GE Energy

MFN 07-009

Docket No. 52-010

Subject: **Response to Portion of NRC Request for Additional Information
Letters No. 79 and 85 – Containment - RAI Numbers 6.2-125 and
6.2-150, and Revised Responses to RAI Numbers 6.2-111 and 6.2-129**

Figure 6.2-125-1

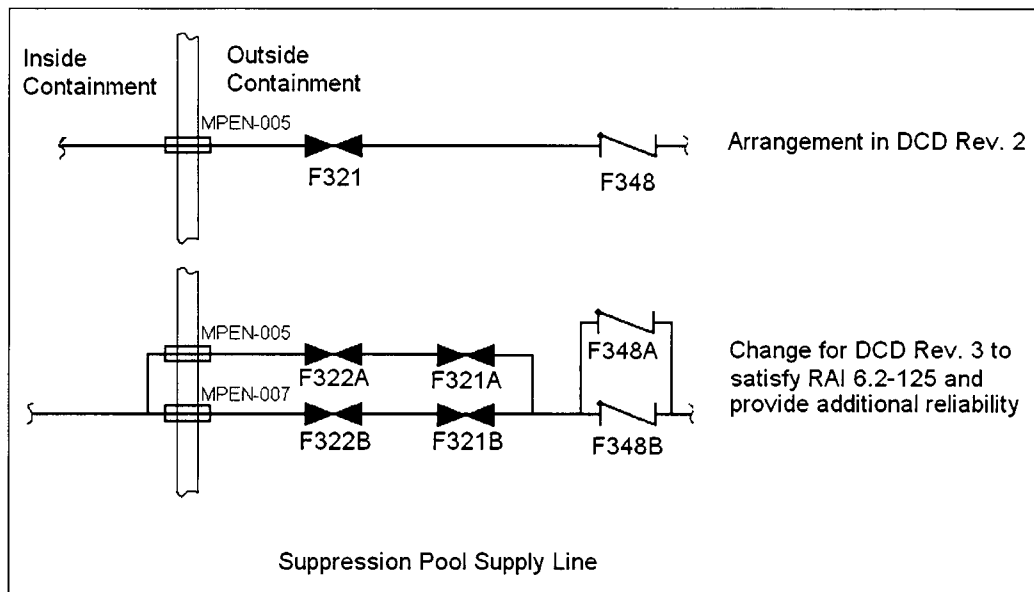
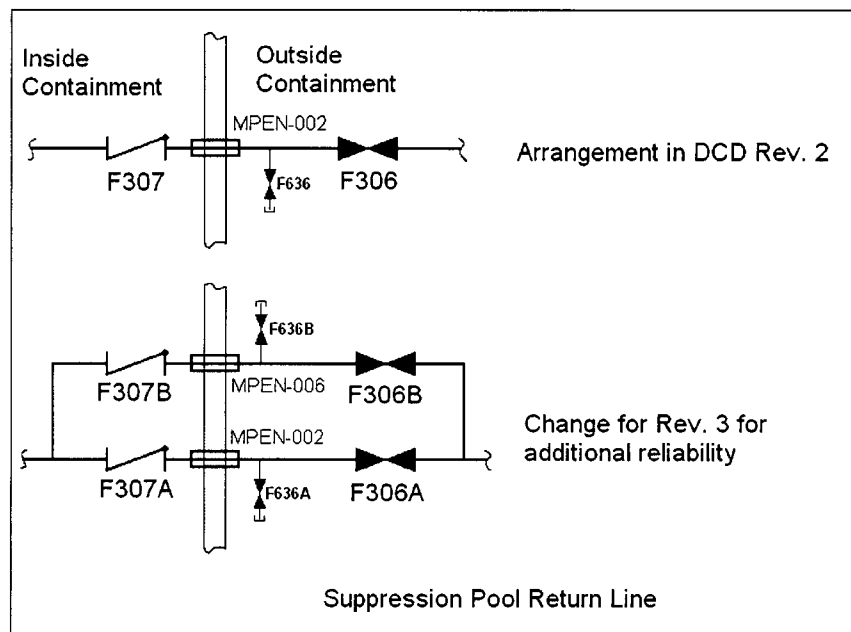
DCD Tier 2, Revision 1, Section 6.2.4.3.2.2, "Effluent Lines from Containment," under the heading "Fuel and Auxiliary Pools Cooling System Suction Lines," states that subsection 9.1.3.3 contains additional information about the containment isolation design for the system including any justifications for deviation from the GDC 56 requirements.

Provide this information in Section 6.2.4.3.2.2.

Further, the design takes credit for a closed system outside containment as the second containment isolation barrier. As detailed in RAI 6.2-102, there are a number of guidelines in SRP 6.2.4, Rev. 2, RG 1.141, and ANS-56.2/ANSI N271-1976 which govern the design of a closed system outside containment when used as a containment isolation barrier. Address these guidelines in the DCD.

The Fuel and Auxiliary Pools Cooling System (FAPCS) is no longer being credited as a closed system outside containment, and as a result a second containment isolation valve has been added to the suppression pool supply line in series with the existing valve. Both valves are located outside the containment and as close to the penetration as possible. The second valve is not located inside containment because it could potentially be submerged by water during a severe accident. This arrangement is acceptable to meet the requirements of 10 CFR 50 Appendix A, GDC 56 and the additional guidelines for acceptable alternate containment isolation provisions for this class of line described in NUREG-0800, Standard Review Plan (SRP) 6.2.4, Section II.d.

In order to improve reliability for the Suppression Pool Cooling and Low Pressure Coolant Injection functions, and to address uncertainty in the Probabilistic Risk Analysis (PRA) safety goals, a parallel redundant flow path through containment has been created for the suppression pool supply and return penetrations. As a result, in addition to adding a second valve in series, there is now a second containment penetration (also containing two outboard containment isolation valves). Likewise, the suppression pool return flow path will now contain an additional penetration with a redundant pneumatic-operated outboard isolation valve and an inboard check valve. The supply and return lines each branch upstream of the containment penetration, and return to a single flow path downstream of the second containment isolation valve. Figures 6.2-125-1 and 6.2-125-2 illustrate this change.
